INDEPENDENT AUDIT OF LOS ALAMOS NATIONAL LABORATORY FOR COMPLIANCE WITH THE CLEAN AIR ACT, 40 CFR 61, SUBPART H

Figure 5. Grid overlay for LANL sampler siting analysis.

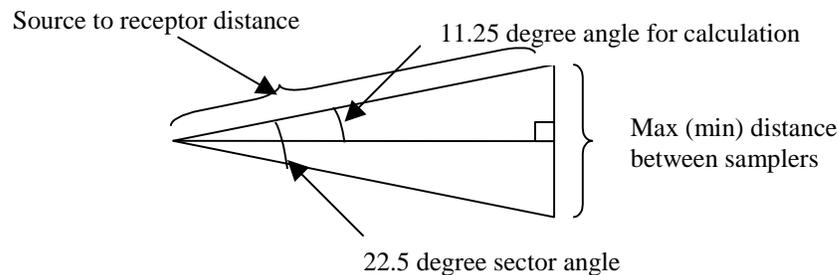
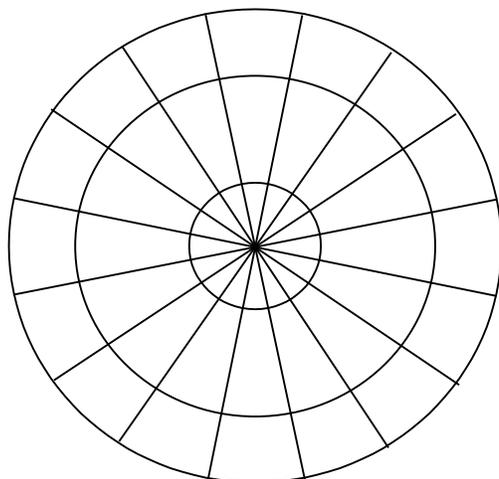
According to 40 CFR 61, Appendix B, Method 4.3.1, LANL has complied with the regulation by describing the rationale for sampler site selection, but the ITAT concluded that the LANL rationale may not produce optimal results. It is important for LANL to show that the sampler network provides adequate coverage. The existing siting analysis does not do this.
